MANDATORY SERVICE BULLETIN NO. MSB 40NG-067 REV. 0

Installation of 7 dB attenuators for aircraft equipped with the Garmin G1000 NXi Phase II installation.

WORK INSTRUCTION WI-MSB 40NG-067 REV. 0

Figure 1. Attenuator installation.

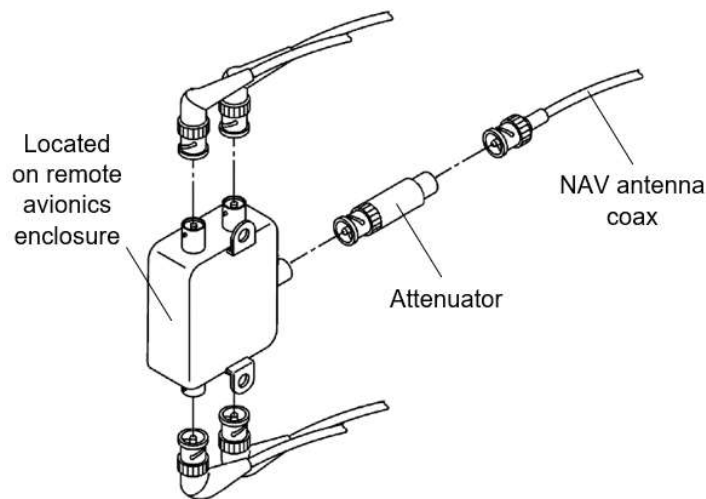
The G1000 NXi Phase II has been approved for installation on DA 40 NG aircraft. It was discovered that the new system was susceptible to electromagnetic interference without the use of 7 dB attenuators. This service bulletin describes installation, of 7 dB attenuators for Phase II equipped aircraft.

1. Remove the baggage compartment. Refer to AMM Section 25-10.
2. Disconnect the main battery. Refer to AMM Section 24-31.
3. Disconnect the ECU backup batteries. Refer to AMM Section 24-31.
4. Remove the HIRF box cover.
5. Install the fixed attenuator (item 1) between the NAV antenna coax and the diplexer (located on the remote avionics enclosure). See Figure 1.
